AMENDMENT OF SOLICITATION/MODIFICATION OF CONTRACT			1. CONTRACT ID CODE J	PAGE OF PAGES 1 3
2. AMENDMENT/MODIFICATION NO. 0002	3. EFFECTIVE DATE 16-Aug-2024	4. REQUISITION/PURCHASE REQ. NO.		5. PROJECT NO.(If applicable)

14. DESCRIPTION OF AMENDMENT/MODIFICATION (Organized by UCF section headings, including solicitation/contract subject matter where feasible.)				
<p>The Solicitation for Republic of Singapore Air Force (RSAF) Facility Renovations for F-16 and F-35 Ebbing NGB, Fort Smith, AR, is amended as follows.</p> <p>See SF30 Continuation Sheet(s)</p> <p>NOTE: Proposal receipt date remains 6 Sep 2024, at 4:00 pm CT.</p>				
Except as provided herein, all terms and conditions of the document referenced in Item 9A or 10A, as heretofore changed, remains unchanged and in full force and effect.				
15A. NAME AND TITLE OF SIGNER (Type or print)		16A. NAME AND TITLE OF CONTRACTING OFFICER (Type or print)		
		TEL:	EMAIL:	
15B. CONTRACTOR/OFFEROR	15C. DATE SIGNED	16B. UNITED STATES OF AMERICA		16C. DATE SIGNED
_____ (Signature of person authorized to sign)		BY _____ (Signature of Contracting Officer)

CHANGES TO SOLICITATION W9126G24R10BP

AD101 DEMOLITION PLAN BUILDING 201

B3 DEMOLITION FLOOR PLAN
1/8" = 1'-0"

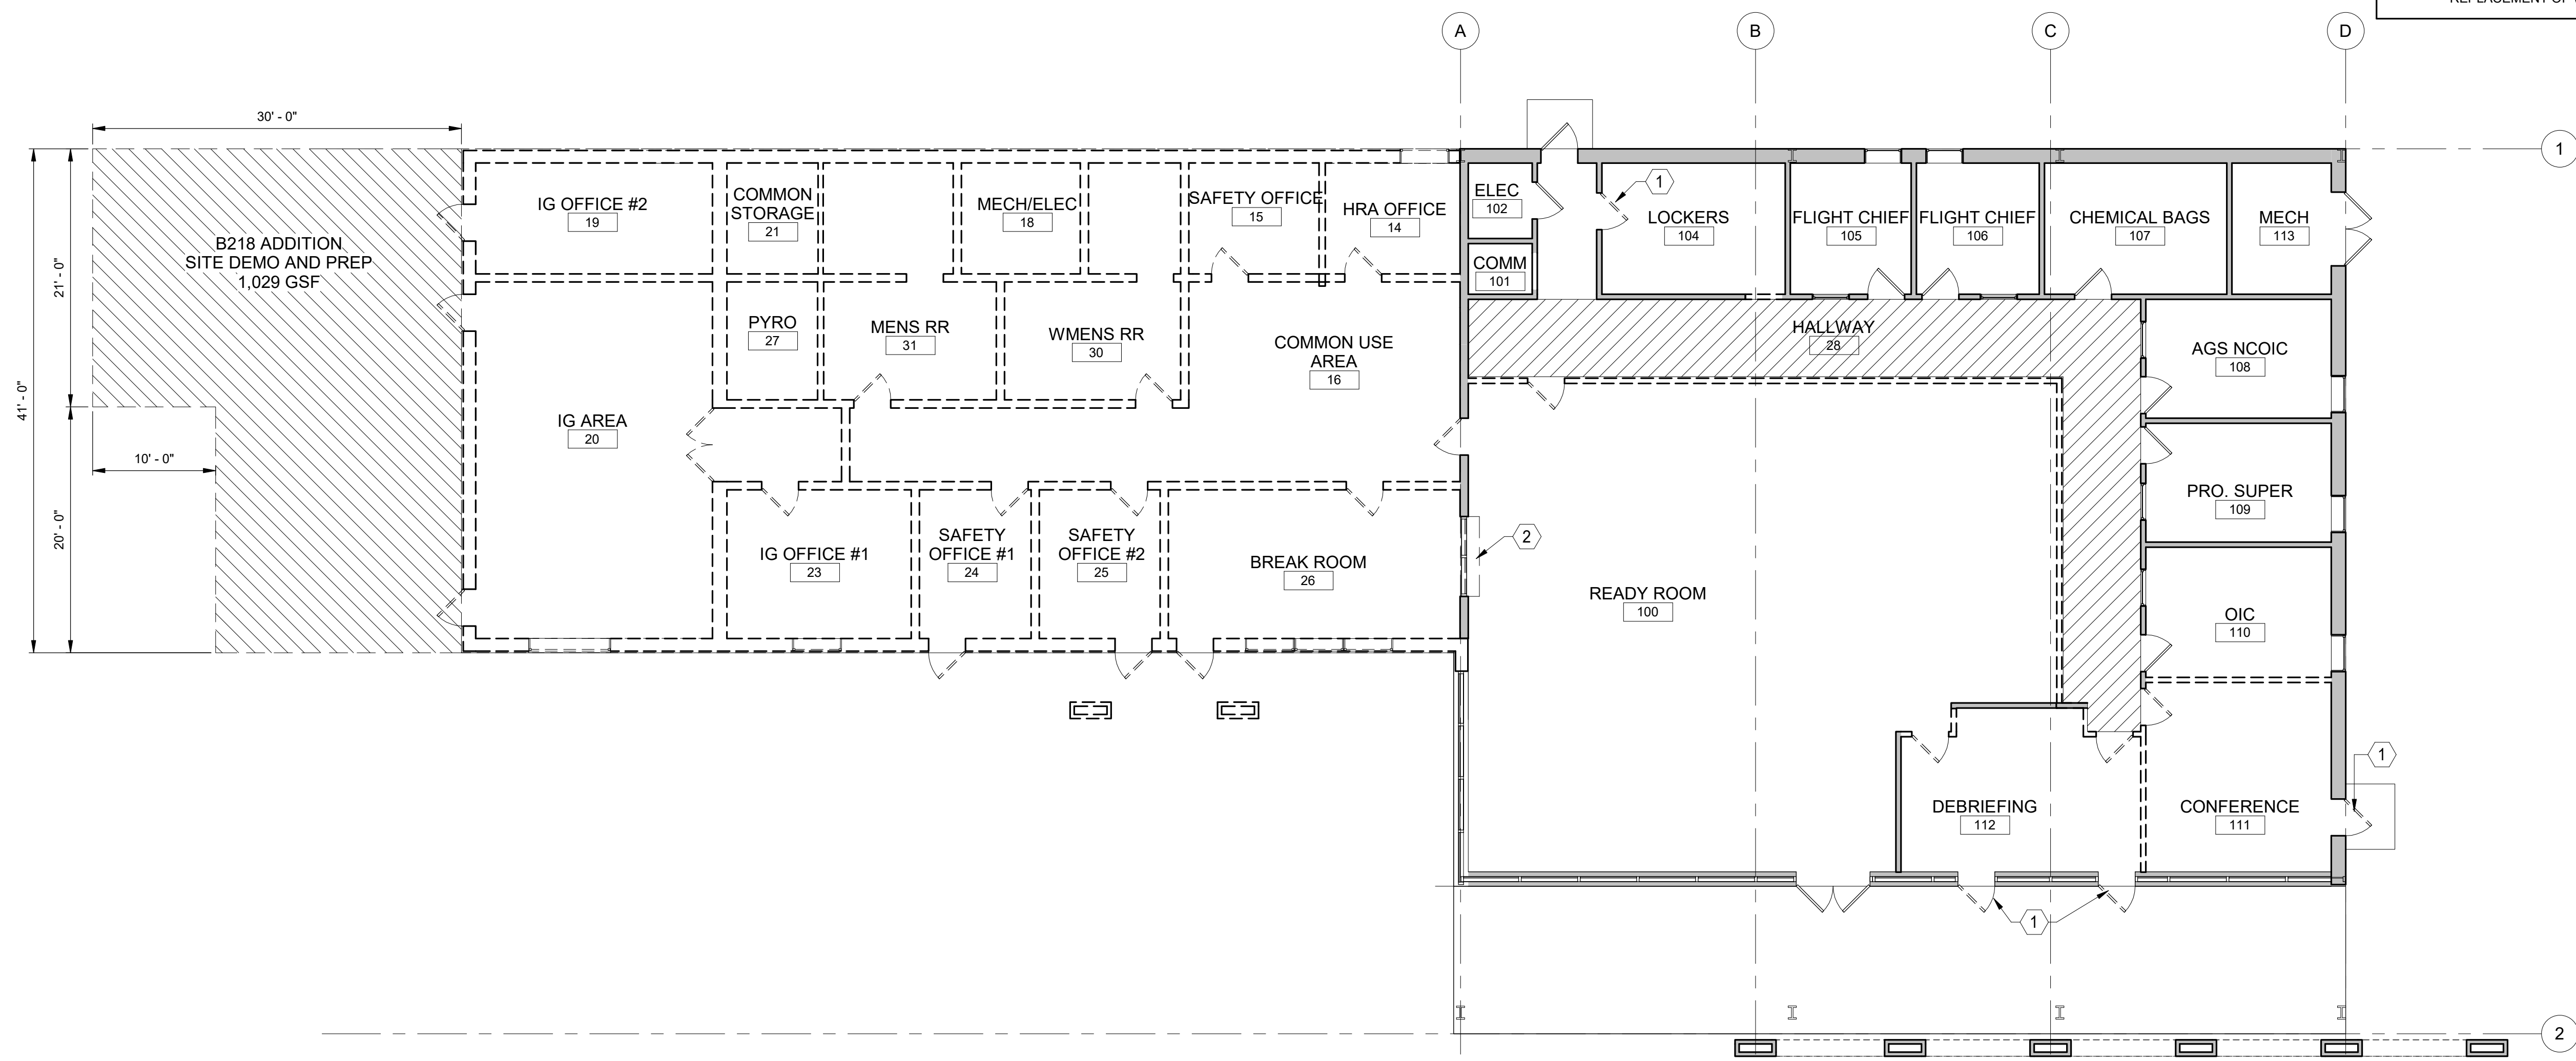
3. Replace the following drawing from Attachment B – Concept Design Drawings bearing the notation W9126G24R10BP-0002.

- EXISTING LOWER PORTION OF FACILITY WEST OF GRIDLINE A SHALL HAVE EXTERIOR WALL AND ROOF SYSTEM BE REMOVED AND REPLACED. EXISTING WINDOWS SHALL EVALUATED UPON REMOVAL TO DETERMINE RE-USE OR REPLACEMENT OF WINDOWS FOR NEW EXTERIOR WALL.
